Agenda
Technical Committee on Lightning Protection
First Draft Meeting
Fort Collins, CO
October 17 - 20, 2017

NFPA 780 SECOND DRAFT MEETING MINUTES
Technical Committee on Standard for the
Installation of Lightning Protection Systems
July 27 – 30, 2015
DoubleTree Hotel Charlotte Airport
Charlotte, NC

Figure L.6.6.1.2 Collection Areas (A_D , A_M , A_L , A_{DJ} , A_I). (Source: IEC.)

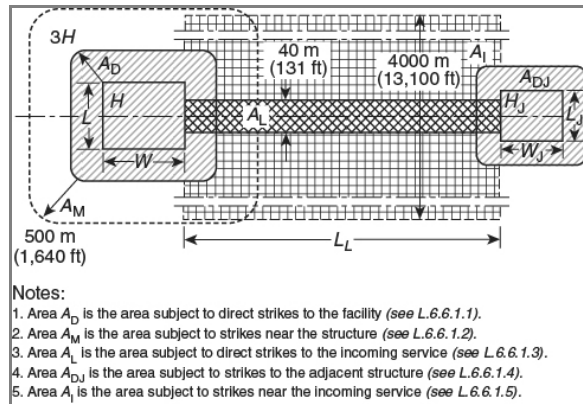
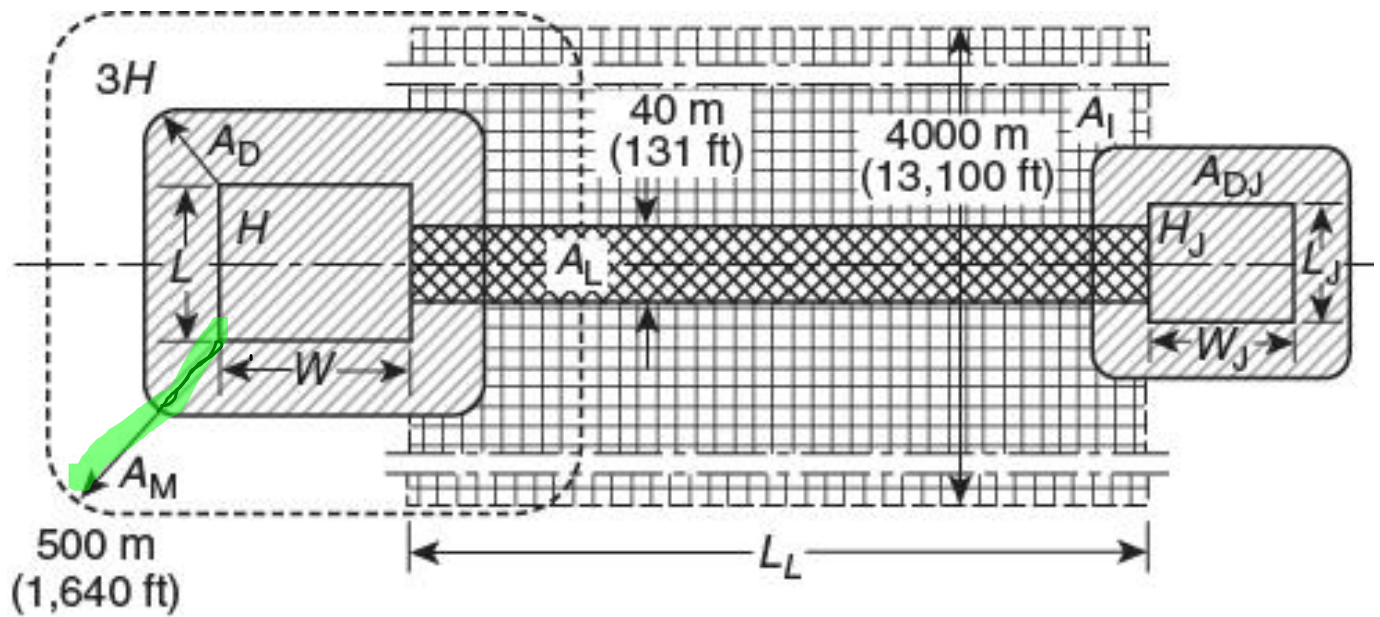
<u>File Name</u>	<u>Description</u>	<u>Approved</u>
Fig_L-6-6-1-2_w_highlighter.pdf	Revision of Figure L.6.6.1.2
